# UNITED STATES PATENT AND TRADEMARK OFFICE

10/732,970

**Office Action Summary**

## DETAILED ACTION

REPLACEMENT  
SHEET 1

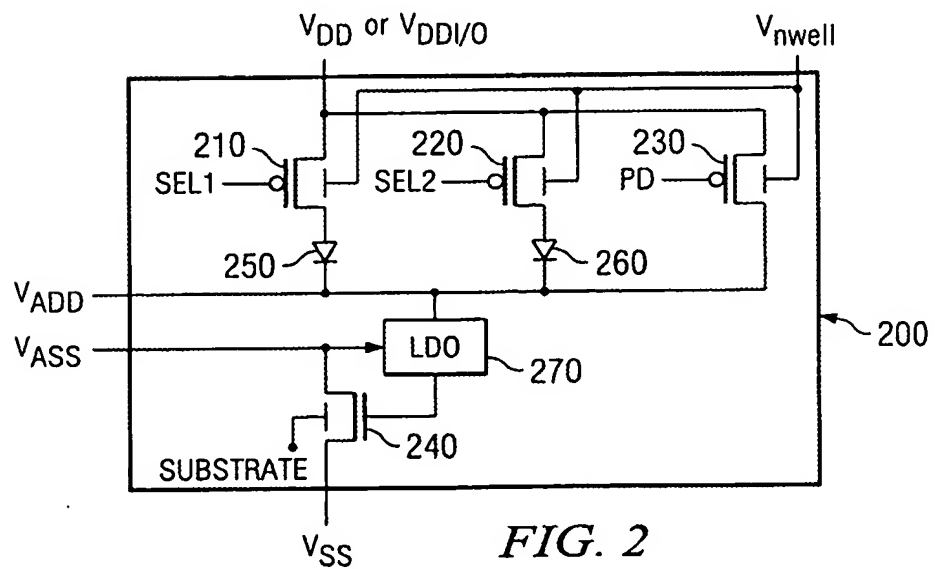
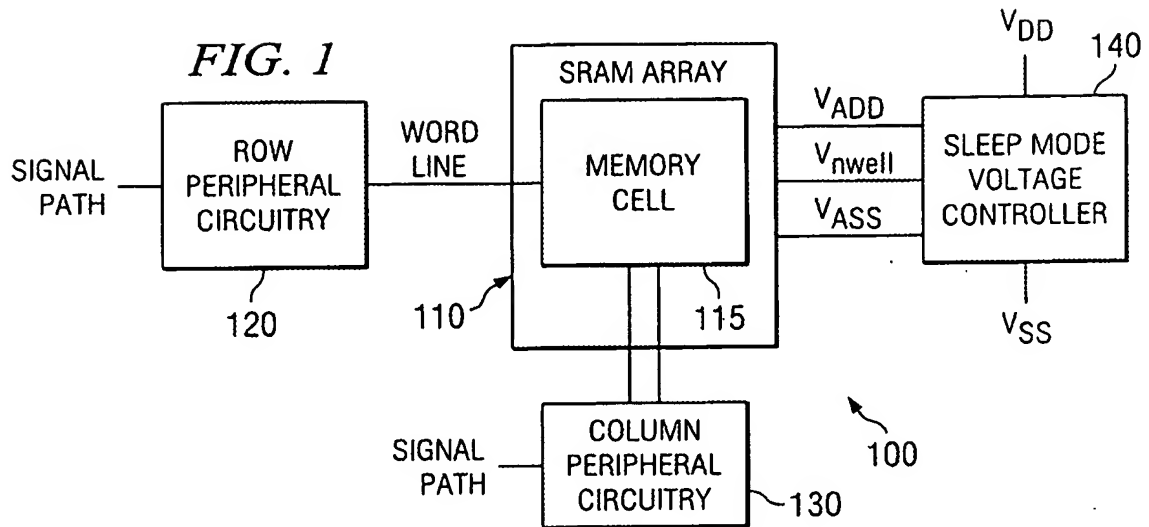
1. The drawings were received on 11/03/05. These drawings have been approved.
2. The drawings are objected to as failing to comply with 37 CFR 1.84(p)(5) because they include the following reference character(s) not mentioned in the description: **VDD or VDDI/O in Fig. 2 (it should be noted that the specification only discloses that n-well may be connected to a high input/output voltage VDDI/O at about 1.8 volts while the high operating voltage VDD is at about 1.2 volts in lines 21-23, page 19 not mentions any thing how the VDD and the VDDI/O are interswitchable.** Corrected drawing sheets in compliance with 37 CFR 1.121(d), or amendment to the specification to add the reference character(s) in the description in compliance with 37 CFR 1.121(b) are required in reply to the Office action to avoid abandonment of the application. Any amended replacement drawing sheet should include all of the figures appearing on the immediate prior version of the sheet, even if only one figure is being amended. Each drawing sheet submitted after the filing date of an application must be labeled in the top margin as either "Replacement Sheet" or "New Sheet" pursuant to 37 CFR 1.121(d). If the changes are not accepted by the examiner, the applicant will be notified and informed of any required corrective action in the next Office action. The objection to the drawings will not be held in abeyance.

3. The drawings are objected to under 37 CFR 1.83(a) because they fail to show: **how the n-well may be connected to a high input/output voltage VDDI/O at about 1.8 volts while the high operating voltage VDD is at about 1.2 volts as described**

**in lines 21-23, page 19 of the specification since Fig. 2 of the present invention does not show any switch or device is used for connecting the V<sub>nwell</sub> voltage to the high input/output voltage VDDI/O or the high operating voltage VDD; how the first switch 210 and the second switch 220 may be connected to the high input/output voltage VDDI/O as describe in lines 1-3, page 20 of the present invention since all three transistors 210, 220 and 230 are commonly connected to VDD or VDDI/O without showing any circuit to break this connection.** Any structural detail that is essential for a proper understanding of the disclosed invention should be shown in the drawing. MPEP § 608.02(d). Corrected drawing sheets in compliance with 37 CFR 1.121(d) are required in reply to the Office action to avoid abandonment of the application. Any amended replacement drawing sheet should include all of the figures appearing on the immediate prior version of the sheet, even if only one figure is being amended. The figure or figure number of an amended drawing should not be labeled as "amended." If a drawing figure is to be canceled, the appropriate figure must be removed from the replacement sheet, and where necessary, the remaining figures must be renumbered and appropriate changes made to the brief description of the several views of the drawings for consistency. Additional replacement sheets may be necessary to show the renumbering of the remaining figures. Each drawing sheet submitted after the filing date of an application must be labeled in the top margin as either "Replacement Sheet" or "New Sheet" pursuant to 37 CFR 1.121(d). If the changes are not accepted by the examiner, the applicant will be notified and

4. The drawings are objected to under 37 CFR 1.83(a). The drawings must show every feature of the invention specified in the claims. Therefore, **the feature “wherein said array high supply voltage VADD and said array low supply voltage VASS are provided concurrently” as newly recited in claims 1, 14 and 24; the features as recited in claims 11 and 23 (it should be noted that in Fig. 1 of the present invention, SRAM array 110 is receiving VADD, Vnwell and VASS voltages; in Fig. 2 of the present invention, the detailed sleep mode voltage controller 200 does not provide the n-well voltage Vnwell and the substrate voltage SUBSTRATE but it is clearly receiving the n-well voltage Vnwell and the substrate voltage SUBSTRATE; p-channel transistors 210, 220 and 230 is back biased the same n-well voltage Vnwell; n-channel transistor 240 is back biased by the substrate voltage SUBSTRATE); the minimum voltage across said SRAM array that is sufficient for data retention as recited in claims 12-13 must be shown or the feature(s) canceled from the claim(s).** No new matter should be entered.
